FRC Comments on Pilgrim's
RETS Submittal (dated April 15, 1983)

April 9, 1984

Comparison of Plant Radiological Effluent Technical Specifications
With NUREG-0473 (Model RETS for BWR)

Figure 4.8.F.1. Reactor Effluent Treatment System Schematic

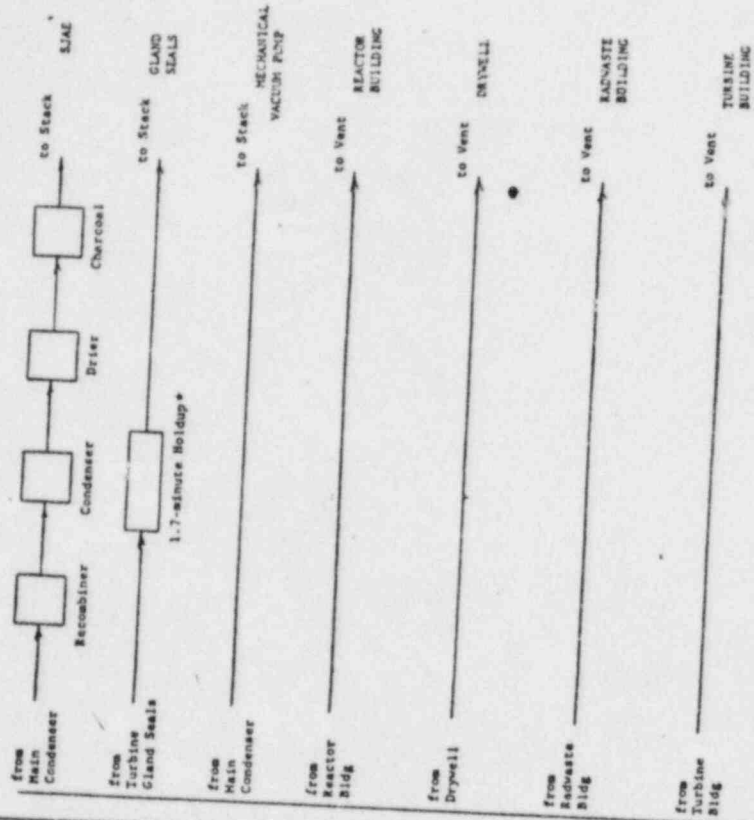
Although Licensee has indicated in the proposed Figure 4.8.F.1 (see attached in p. 21-A) that turbine building "vent" is a sub-system to "vent", however it is not clear if this "vent" is meant for the reactor building vent. Licensee should clarify this issue.

Figure S-1-1. Pilgrim Nuclear Power Station Unrestricted Areas for Liquid and Gaseous Effluents

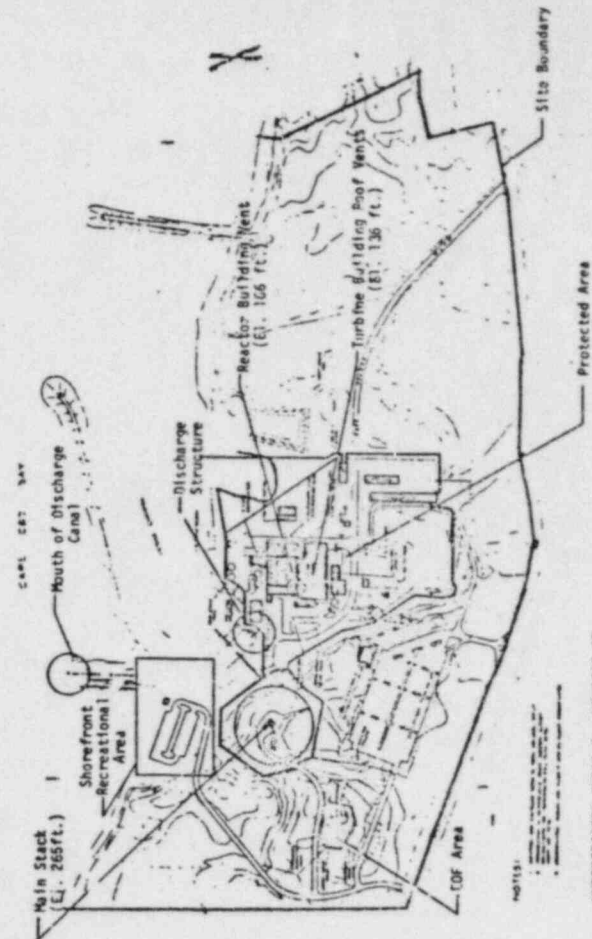
Licensee should include the scale factor in the map.
